Planning Application 22/01037/MAO – Hill Farm, Sharnbrook

Sharnbrook Parish Council have considered the above application, and have the following comments to make on the outline proposal.

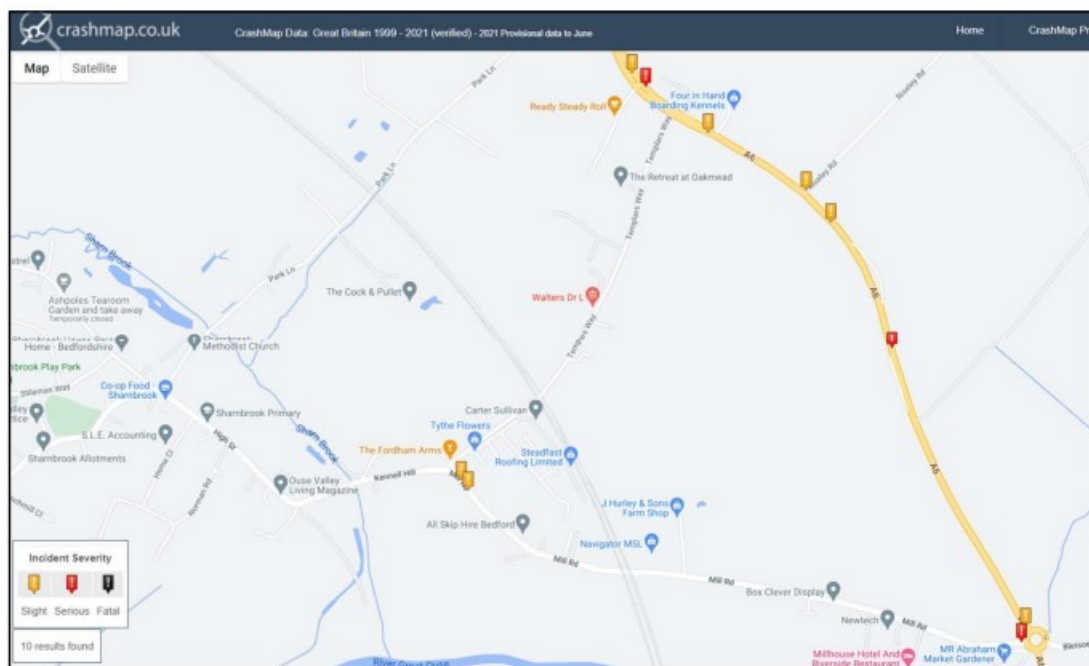
- Extend the proposed foot/cycleway along to the junction and continue along the southern side of Kennell Hill and terminate this near Christmas Cottage. This would add approximately 240m of dedicated cycling provision and removes/reduces potential conflict with vehicles at the junction of Templars Way with Kennell Hill/Mill Road.

- In parallel with the above, additional traffic calming measures to aid compliance to the 30mph (or less) could be considered along Mill Road and Kennell Hill respectively, at appropriate points. Measures could be both physical and physiological, and implementation of such could partly compensate for lack of dedicated cycling facilities and enhance safety between the existing village and the development site.

- Extend foot/cycleway further along Templars Way beyond the small pocket of properties on its southern side. Here you could then provide a footway/cycleway link to the parcel of land to the very north of the site. At present, the green corridor prevents/complicates permeability to this northern parcel.

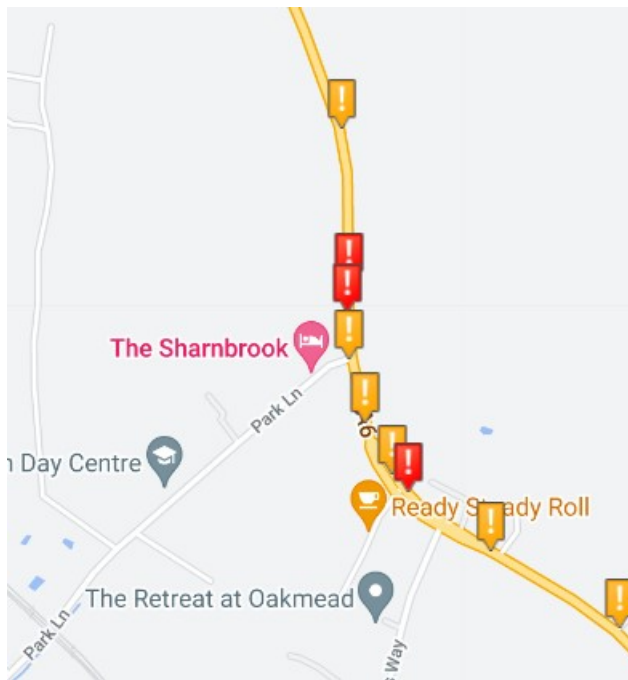
The Transport Assessment has used a detailed analysis of Crashmap focusing on the site and immediate surrounds. However, using the Stats 19 information held by Bedford Borough Council and taking a slightly wider look at the local roads, it is clear that there are significantly more safety issues just outside the immediate area. Furthermore, the study uses the period 2020-21, which was a period when the whole country was under frequent travel restrictions due to Covid-19, and is therefore not typical of traffic flows before or after this period.

Even using the Crashmap figures, the study area and analysis of collision fails to recognise that immediately north of Templers Way, there are several collisions sufficient in our view to be considered as a cluster site worthy of separate consideration. A further 4 collisions can be found further north than those reported on in the TA, and their omission from the figures undermines the statement in 3.48 that there is no indication of a cluster site. An extract from Crash map is reproduced in below and shows that if the study area is extended slightly, there is a clear cluster site in this section of the A6.

- Failure to acknowledge a cluster site just beyond the agreed study area, which could be classified as a cluster site likely to be impacted by the development;
- Use of 2020 & 2021 data sets, which were not representative of normal network conditions owing to restrictions placed on the population, and;
- Use of Crashmap instead of Stats 19 data.
